Application to Amend a Planning Permit S72

| Planning Application No: | PLA0046/24 |
| Address: | 94 Murray Road MODELLA |

Proposed Shed

Proposed Site Plan
Scale: 1:600.00

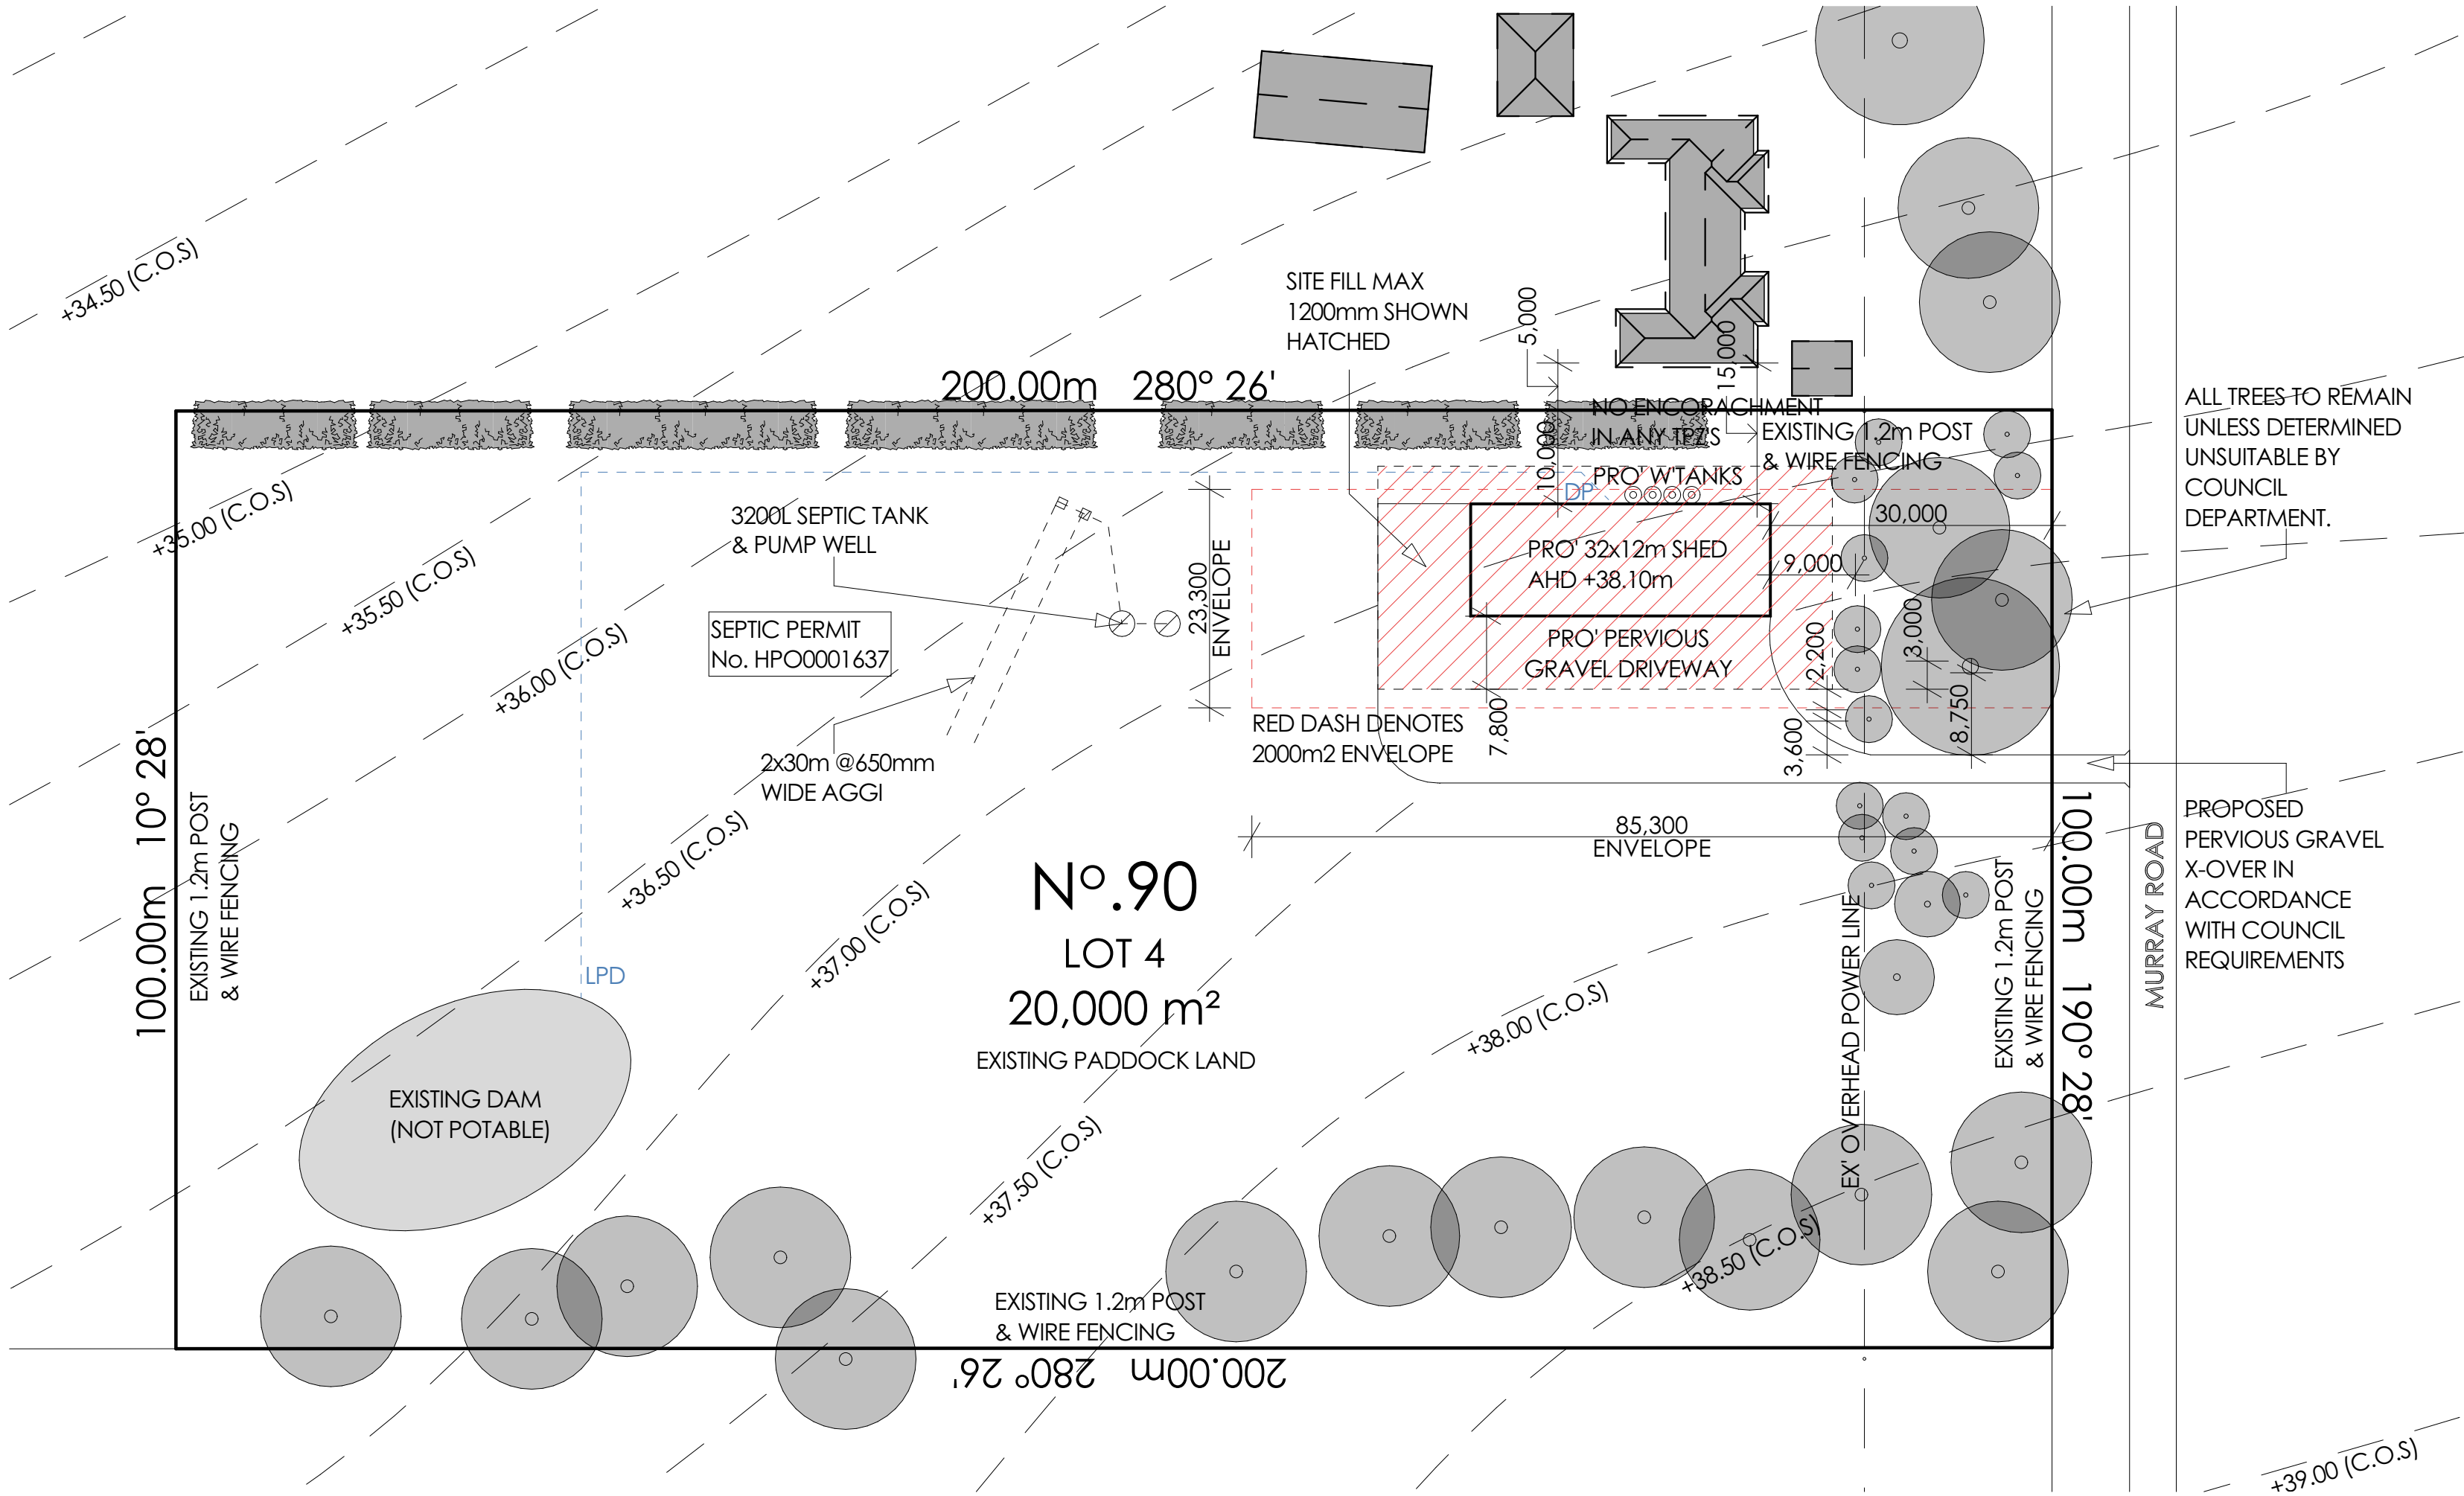
| Skillion roof instead of gable. New front setback |
